# CIT PLANNING COMMISSION

**APPLICATION:** A. Negative Declaration  
 B. Special Permit to construct a 24,835 square foot office, warehouse building in the Norwood/I-80 Business Park PUD (Sec. 8-C-3)

**LOCATION:** Southeast corner of Norwood Avenue and I-80

# LANDSCAPE PLAN

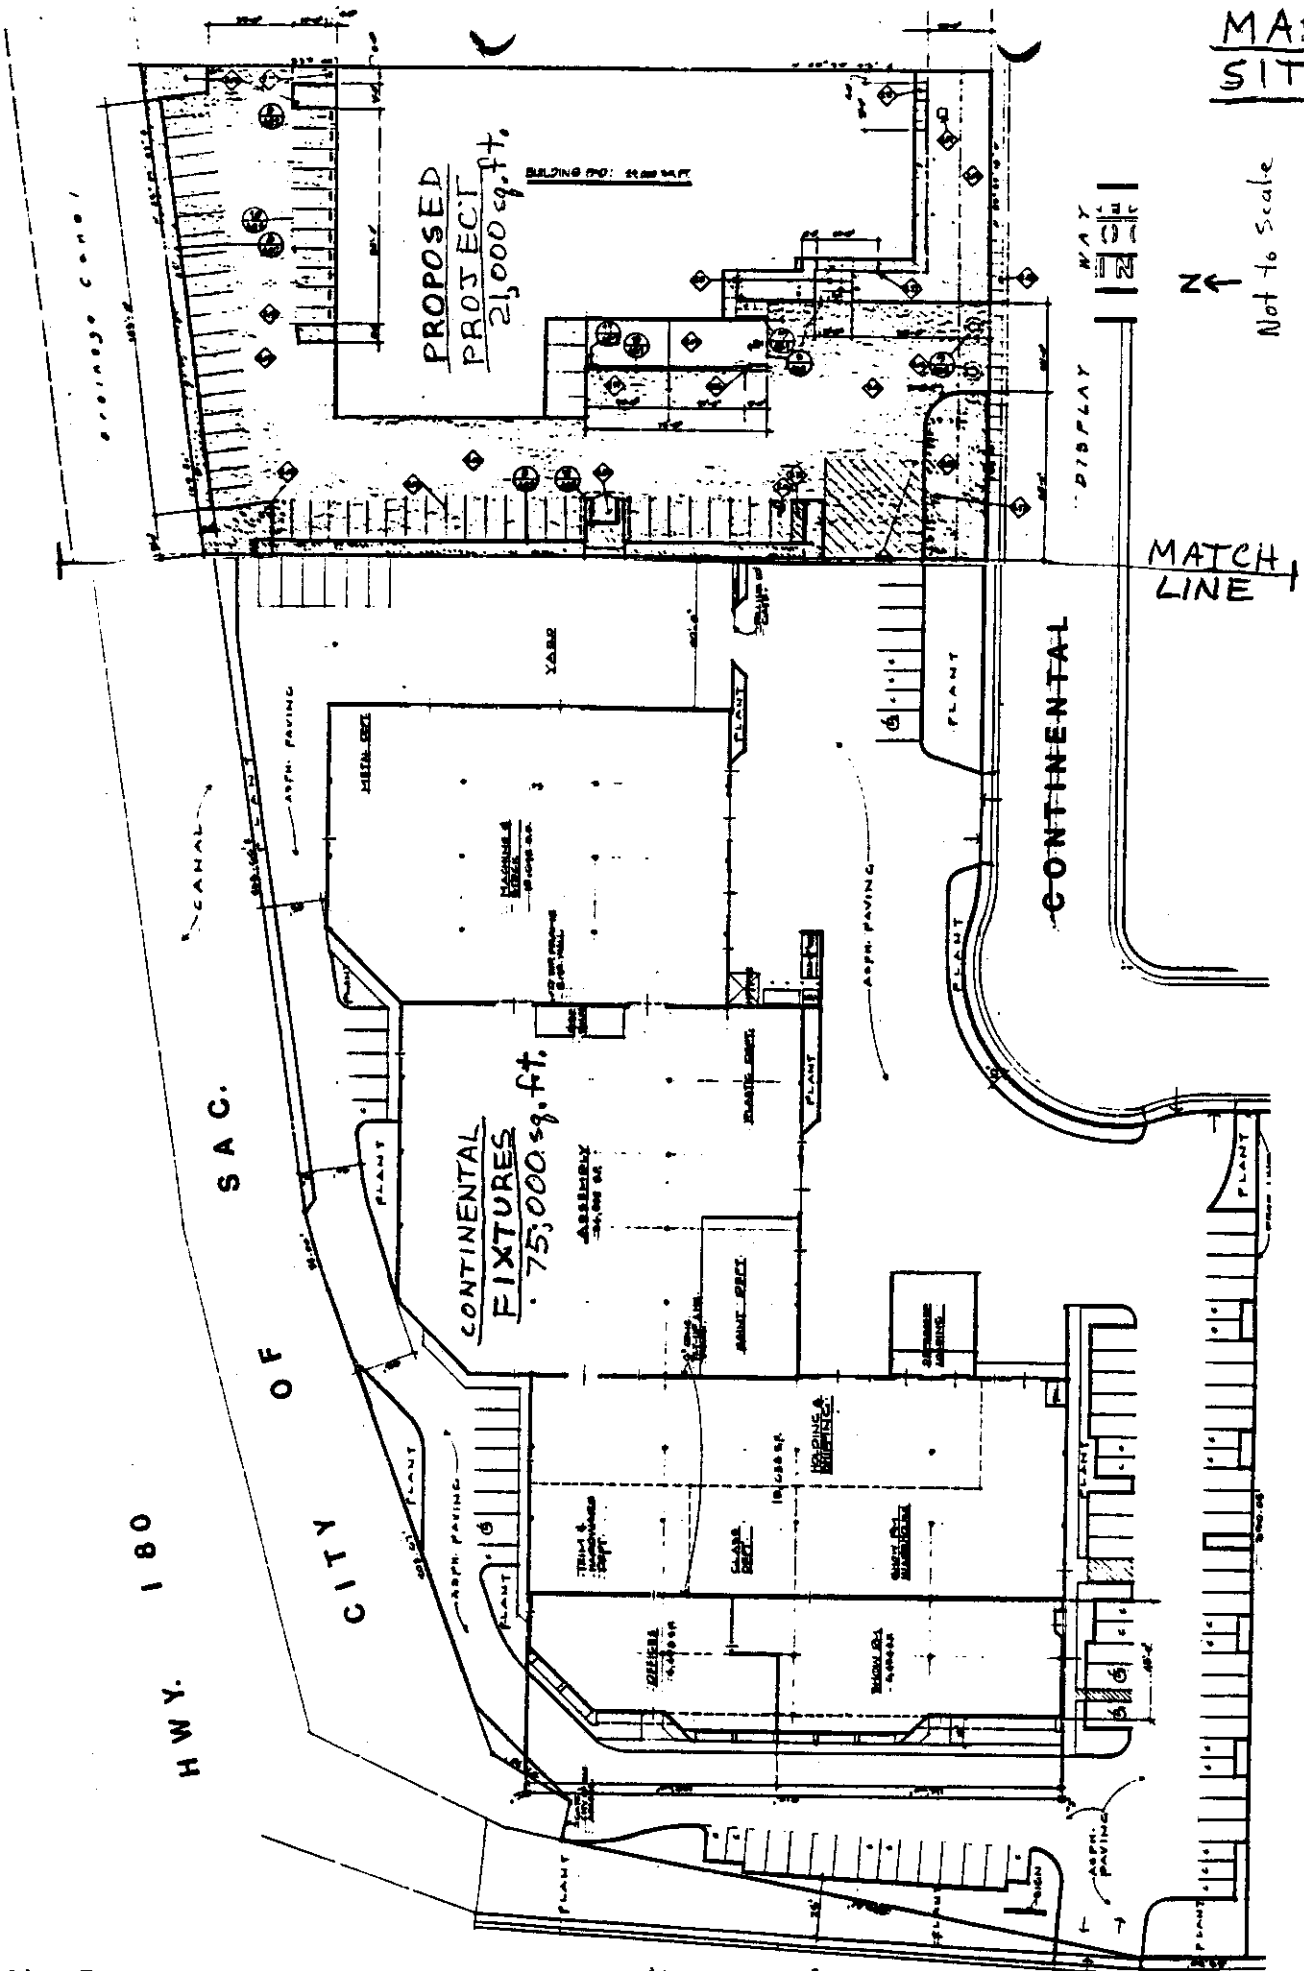
4. The six foot wide landscape strip is required to have evergreen trees planted every 15 lineal feet along the north property line. The Chinese Hackberry is a deciduous tree shown on 25 to 30 foot centers.

7. Landscaping along the west and south property lines is required to have trees a minimum of one tree per 25 lined feet.
8. Landscaping mix in the 25 foot front yard setback is to include 24 foot box specimin, 15 gallon and 5 gallon size trees with shrubs in 5 and 1 gallon sizes. The proposed landscaping plans use only 15 gallon size trees and no shrubs are indicated.

- a. The 25 foot front yard landscape setback shall be mounded in three to four foot mounds with intensive tree and shrub coverage.
  - b. Additional trees shall be planted along the north property line to screen the building. The PUD Guidelines require evergreen trees on 15 foot centers along the planter strip. A variety of 24 inch specimen, 15 gallon and 5 gallon trees are required with 5 and 1 gallon size shrubs.

# SITE PLAN

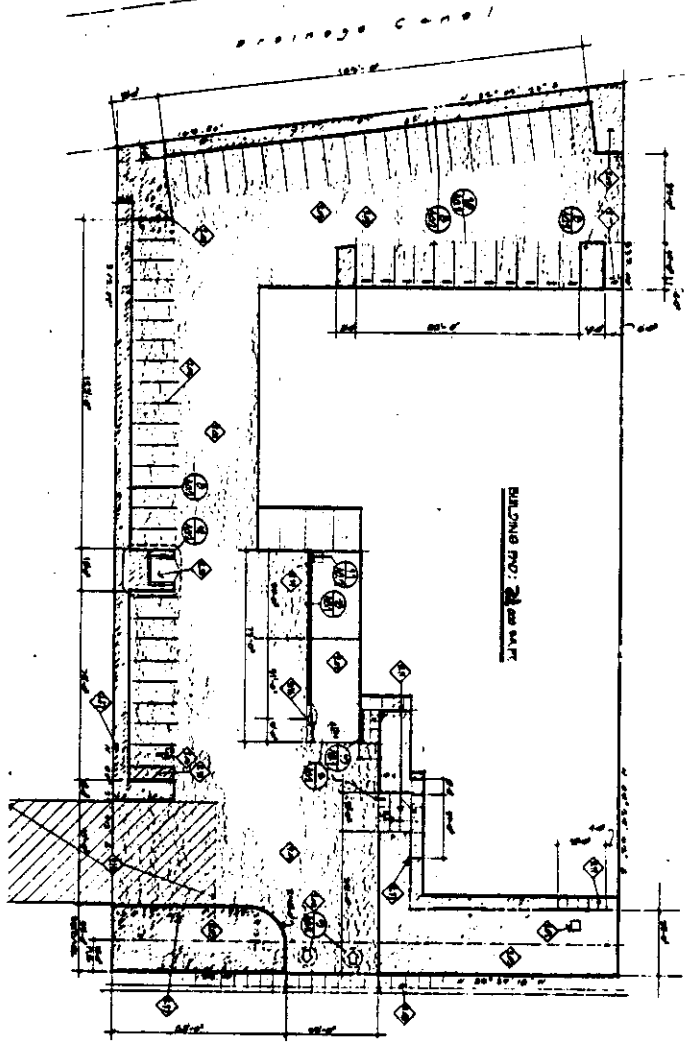
The proposed driveway on the west property line will require a reciprocal access agreement with the owners of Continental Fixtures. Construction of the driveway will also eliminate eight parking spaces shown on the site plan for Continental Fixtures. The applicant is working with Continental Fixtures to relocate the eight spaces in order for the reciprocal driveway access to function. The site plan will require revision to show the relocation of eight spaces to the satisfaction of the Planning Director and Building Inspector.

1. No individual prefabricated wheel stops are allowed in the PUD. The north building elevation has a row of car stalls which will require either a four wide continuous landscape strip with curb or a continuous concrete curb a minimum of two feet from the building wall.

2. No compact car stalls are shown. A minimum of 30 percent of the required spaces should be designed for compact cars and so marked.
3. All interior property lines require a four foot wide continuous landscape strip. The northeast corner should show landscaping along the east property line.

- h. The trash enclosure shall comply with the PUD trash enclosure guidelines.
  - i. No wheel stops are allowed along the north wall parking spaces. Applicant shall install a minimum four foot planter strip along the north wall with a two foot vehicle overhang adjacent to the stall or installation of a continuous concrete curb a minimum of two feet from the north wall.

- j. Staff recommends the shortening of parking spaces from 18 to 16 feet and incorporate two feet of vehicle overhang into the planters along the property line.

- 2. A sign program shall be submitted to the Planning Director for review and approval prior to issuance of any sign permit.
  - 3. The applicant shall obtain a reciprocal access agreement for the driveway shown adjoining Continental Fixtures' property.

ELEVATIONS

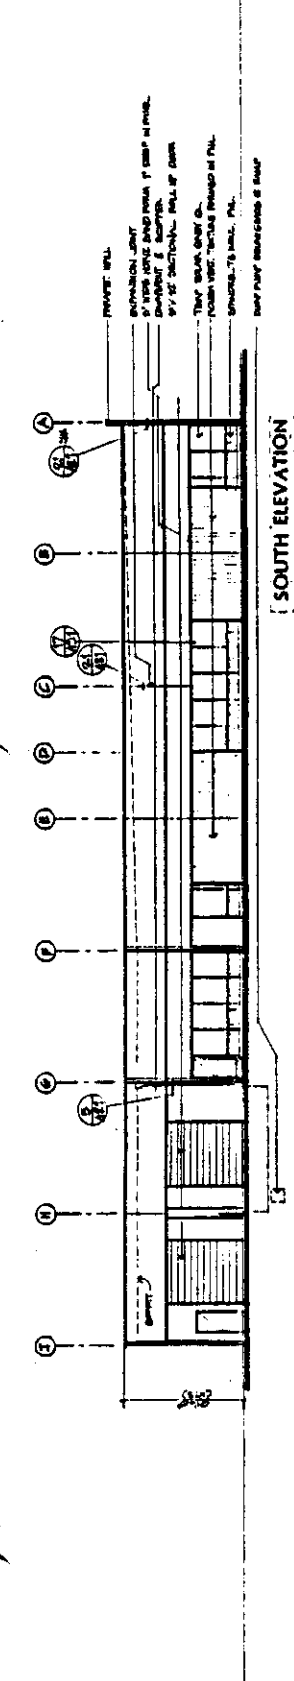
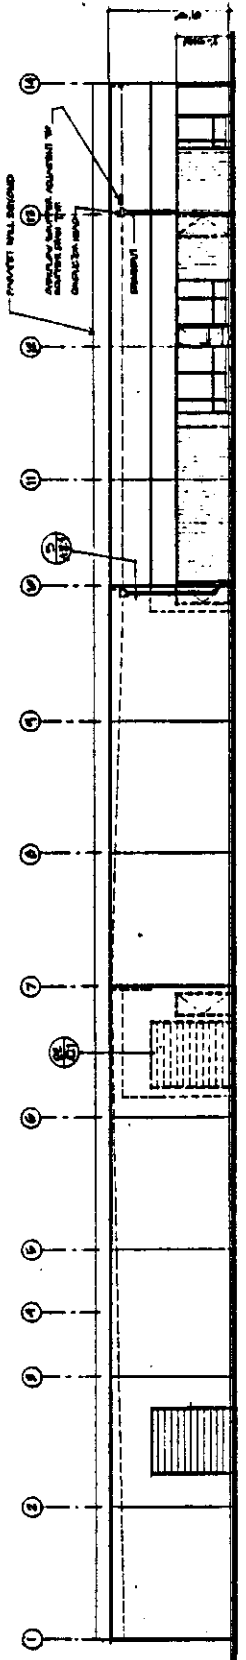
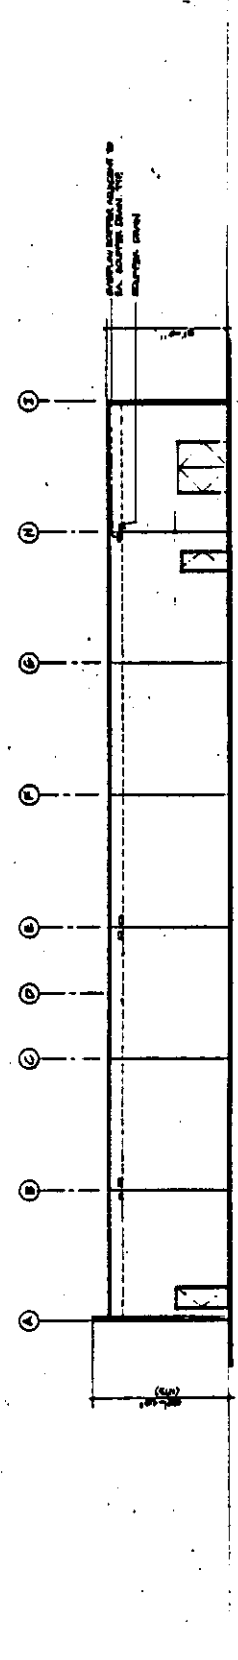
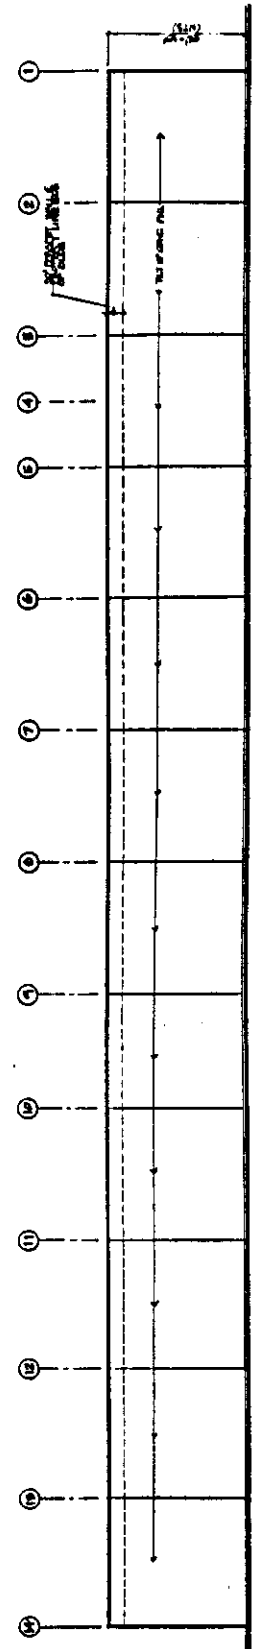
Staff recommends that the north and east elevations, which are visible from the Interstate 80 right-of-way, provide continuation of the two three

inch wide bands in order to break up the large panel surface. Staff also suggests the formliner fluting element be extended around the structure along the top portion of the tilt-up panels to provide visual relief.

No colors are indicated for the roll up doors. Staff recommends that they be painted a color to match the wall surface of the concrete tilt up panels.

- c. No roll up doors are allowed facing the freeway.
  - d. The exterior elevation shall be revised to show continued horizontal trim band. The use of two three inch wide horizontal form line bands one inch deep shall be painted in a contrasting color compatible with the trim around the entire building.

- e. Revised elevations shall show textured concrete surface, not a smooth unfinished surface as shown.
  - f. Revised elevations shall show a two to three-foot wide formliner showing vertical fluting along the top portion of the tilt-up panels to enhance the variations of the wall. The formliner shall surround the entire building and provide relief through depth and contrasting texture. The applicant may eliminate the formliner over the south and west elevation where textured form liner is provided on lower portion of tilt-up panel if they so choose.

- g. All rollup doors shall be painted the same color as the walls.
